Subject: Duke Energy Carolinas, LLC.
William States Lee III Nuclear Station - Docket Nos. 52-018 and 52-019
AP1000 Combined License Application for the
William States Lee III Nuclear Station Units 1 and 2
Response to Request for Additional Information
(RAI No. 451)
Ltr# WLG2008.12-22

Lee Nuclear Station Response to Request for Additional Information (RAI)

Reference NRC RAI Number(s): RAI 02.03.05-001

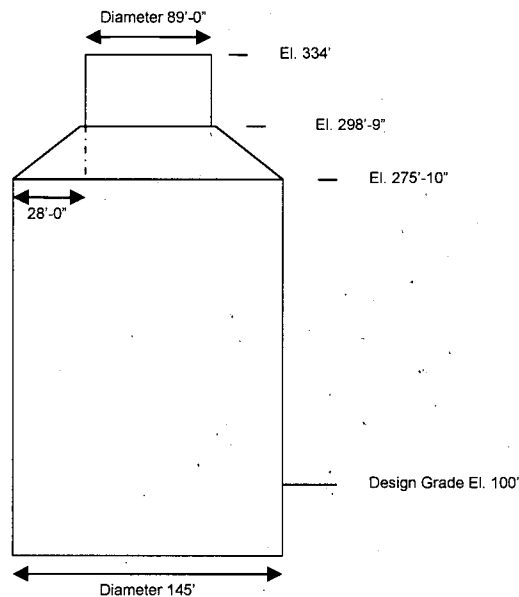
Please provide a reference to the AP1000 DCD section for the building cross-sectional area and containment height used as input to the XOQDOQ model.

Using these dimensions from AP1000 DCD, Revision 15, the following outline of the Shield Building can be determined:

Using this figure, the Shield Building above grade cross-sectional area is 31,313 ft² (2,909 m²), and the above grade Shield Building height is 234 ft (71.3 m).

Some of the Shield Building dimensions changed between Revision 15 and Revision 16 of the AP1000 DCD. The dimensions based on AP1000 DCD Tier 1, Revision 16, Table 3.3-1, and Westinghouse drawing APP-1000-P2-902, Revision 1 (Reference 2), are given below:

Using these dimensions from AP1000 DCD, Revision 16, the Shield Building above grade cross-sectional area is 30,594 ft² (2,842 m²), and the above grade Shield Building height is 229 ft (69.8 m).

A sensitivity study was performed to determine the effects of the changes in Shield Building cross-sectional area and height on the routine X/Q values. Based on the sensitivity study, the effects were determined to be negligible. Therefore, the X/Q values calculated using the Shield Building cross-sectional area and height determined from AP1000 DCD, Revision 15, and Westinghouse drawing APP-1000-P2-902, Revision 0 (Reference 1), were maintained in the FSAR (Note that the Shield Building dimensions are unchanged from DCD Revision 16 to Revision 17).
